# Rezoning Transportation Analysis

Petition Number: 2016-115

General Location Identifier: 04742101, 04742102, 04742106

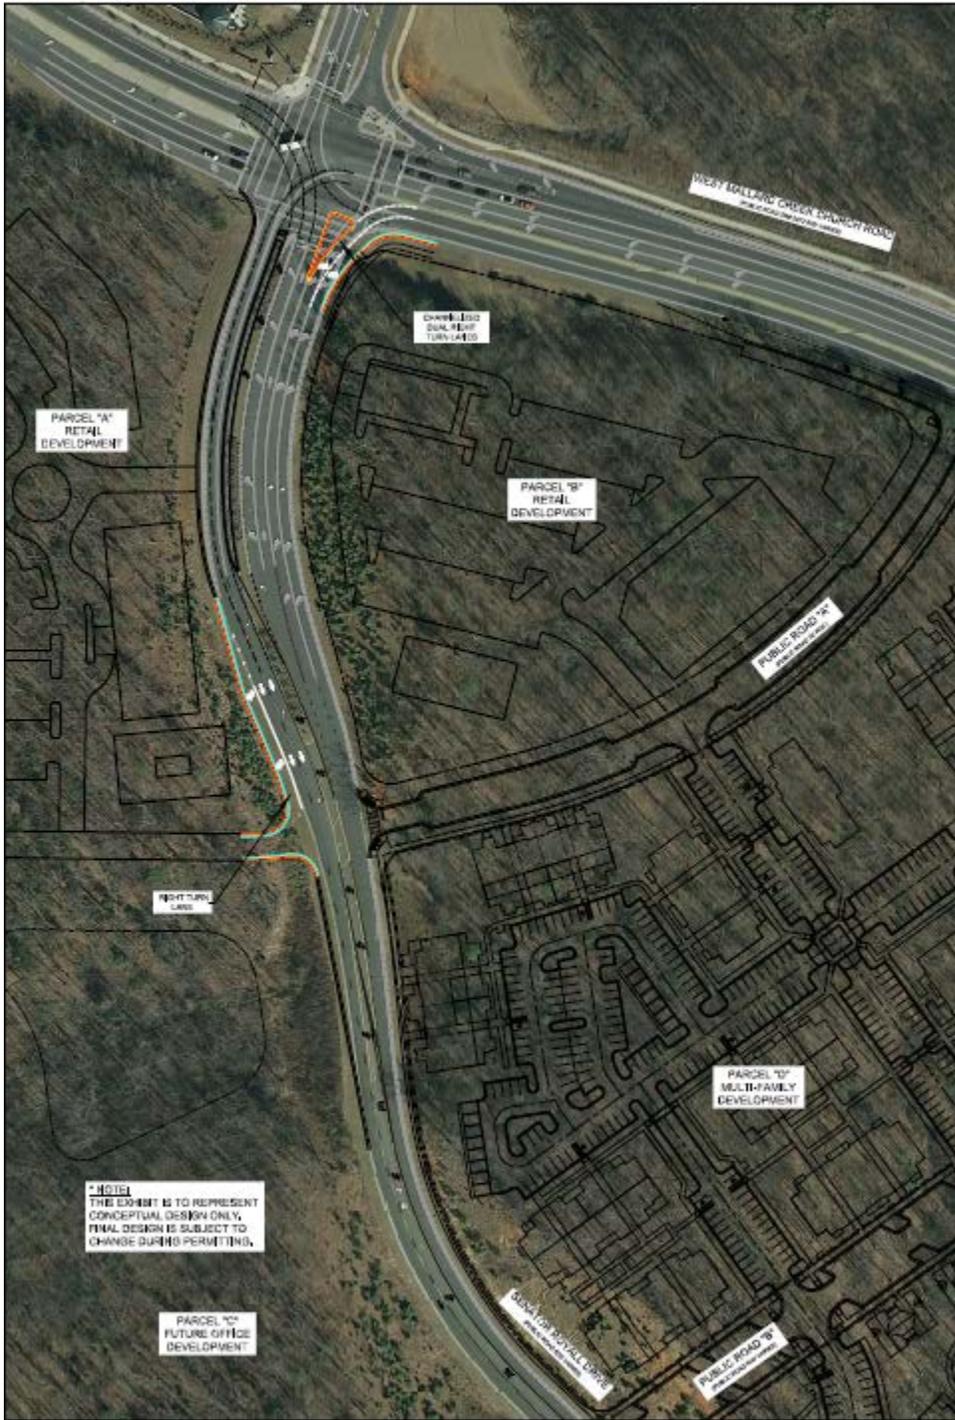
7. Include Parcel “C” Improvements - the extension of the existing SB Senator Royall Dr. outside travel lane for approximately 730 feet to Heritage Pond Dr. as a right-turn only lane. The widening of

Senator Royall Dr. includes an 8' raised landscaped median, and up to three (3) pedestrian refuge islands located at Alexander Village Main Dr., Heritage Pond Dr. and one to be determined during the construction permitting process (see below exhibit).

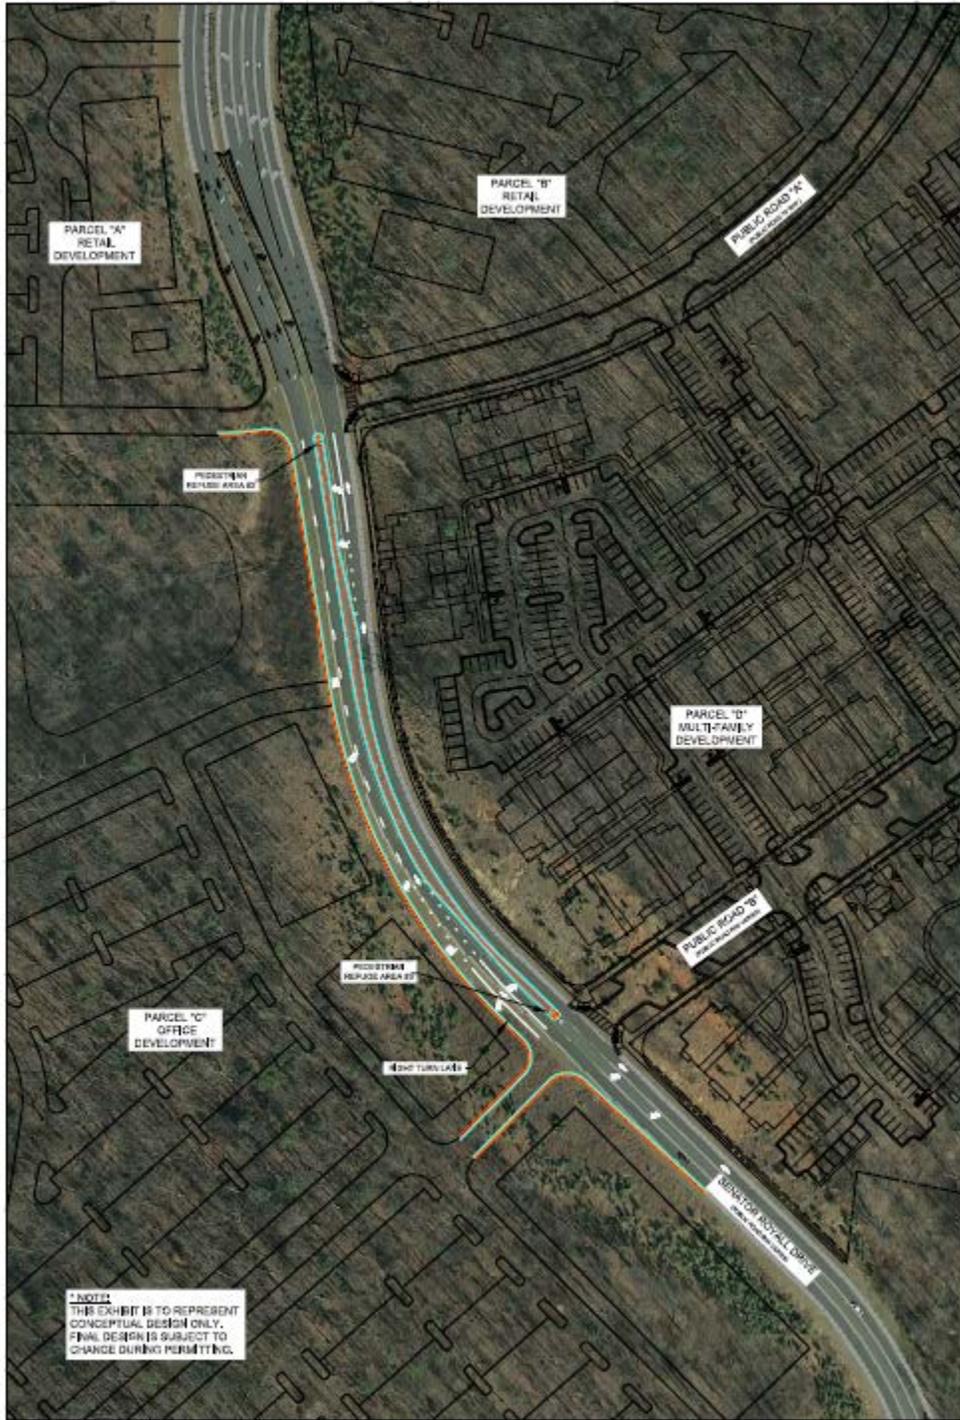
- a. An additional NB Senator Royall Dr. 200’ left turn storage lane w/appropriate bay taper length at Mallard Creek Church Rd. (the existing Senator Royall Dr. median must remain 8’ wide to provide adequate pedestrian refuge space) (see below exhibit).

- b. Channelized NB dual right turn lanes with protected traffic signal pedestrian phasing (see below exhibit).
  - c. Traffic signal modifications to accommodate the NB dual lefts and NB dual right turns on Senator Royall Dr. NB approach at Mallard Creek Church Rd. (see exhibits below).
